PRELIMINARY DRAINAGE REPORT
for
WINDERMERE FILING NO. 2

Engineering Review

**EPC Planning & Community
Development Department**

DR

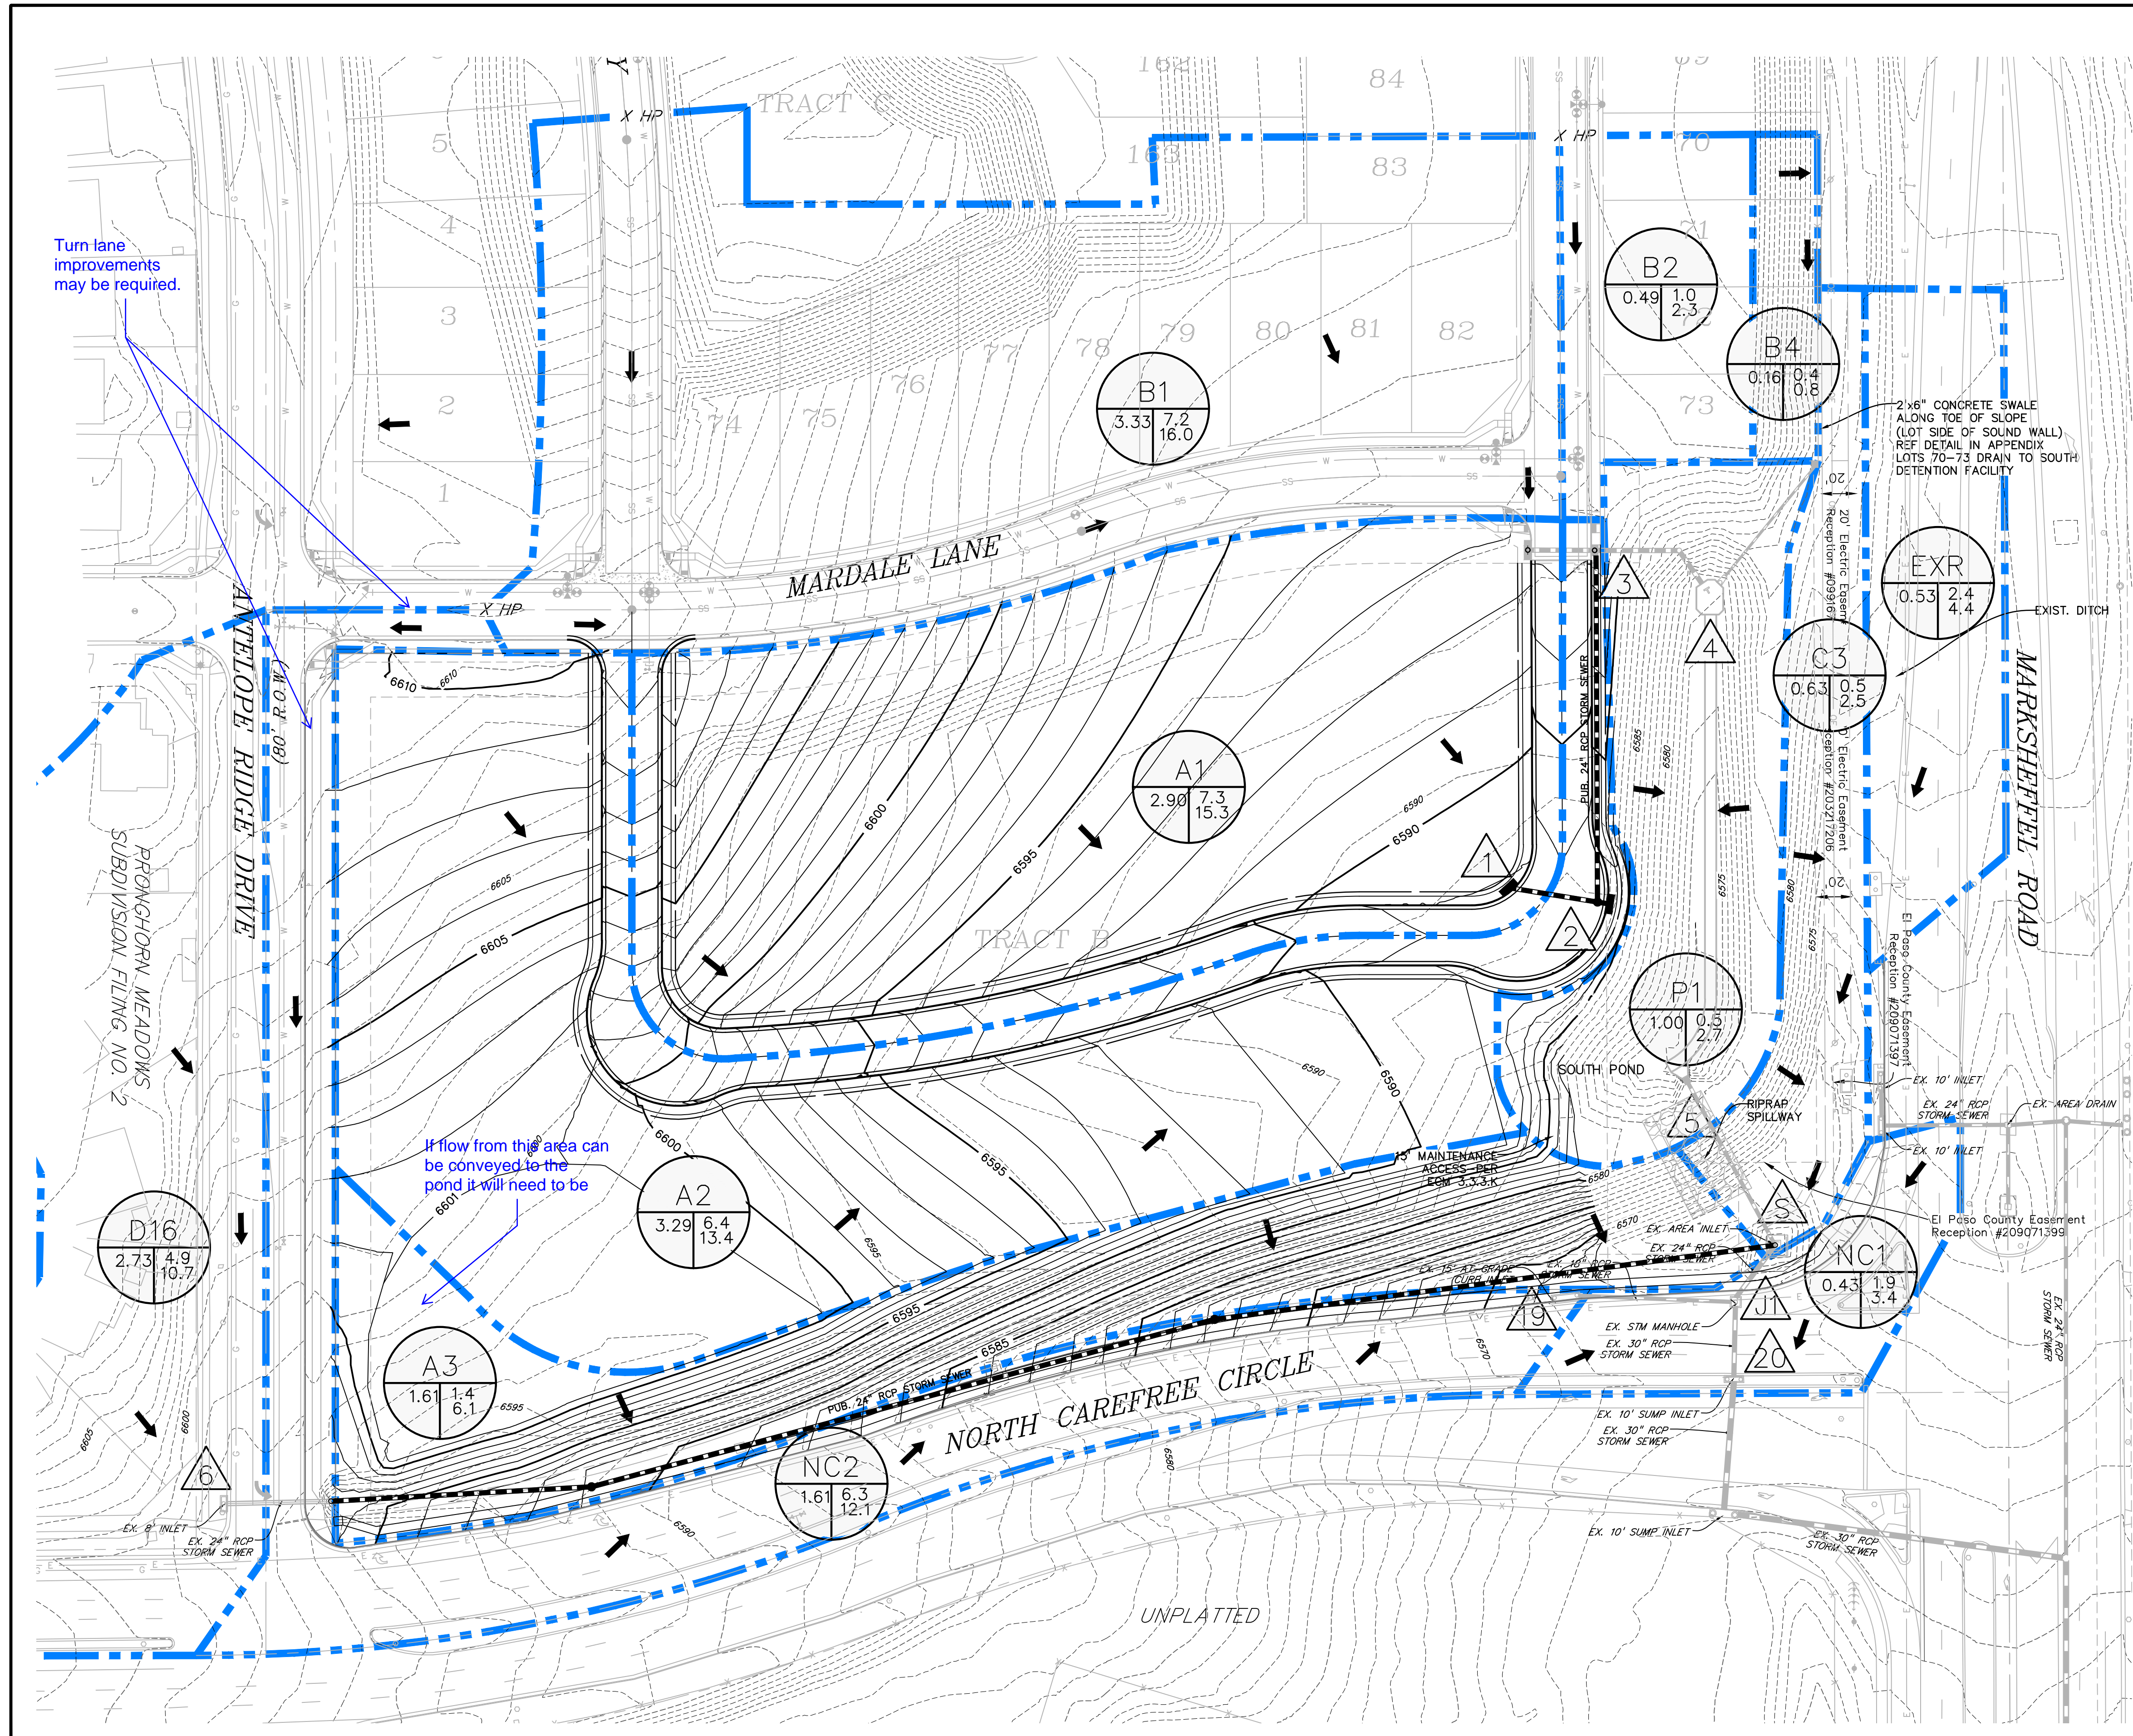
Turn lane improvements may be required.

If flow from this area can be conveyed to the pond it will need to be

Provide a Water Quality Areas Plan
